**Inability to select programmes on SMART tumble dryers**

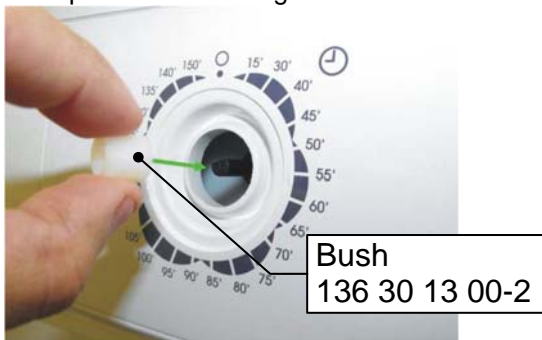
On ventilated tumble dryers featuring SMART styling, which are easily recognised by the typical programme selector knob on the control panel (fig.1), it has been noticed that the pin connecting the knob to the programme selector on the circuit board detaches itself, thereby not allowing the user to select a programme.

The problem is caused by the excessive distance (A fig 2) between the knob and the retainer ring of the selector pin.

To solve this problem, a bush should be inserted onto the pin connecting the knob to the programme selector, on all appliances - whether affected by this problem or not - as shown in the figure, in order to prevent the pin from becoming detached from the selector on the board.

If it is too difficult to remove the knob, it is advisable not to insist in order to avoid damaging the knob holding clips. Instead, remove the entire board support as specified in the service manual.

Bush PN 136 30 13 00-2
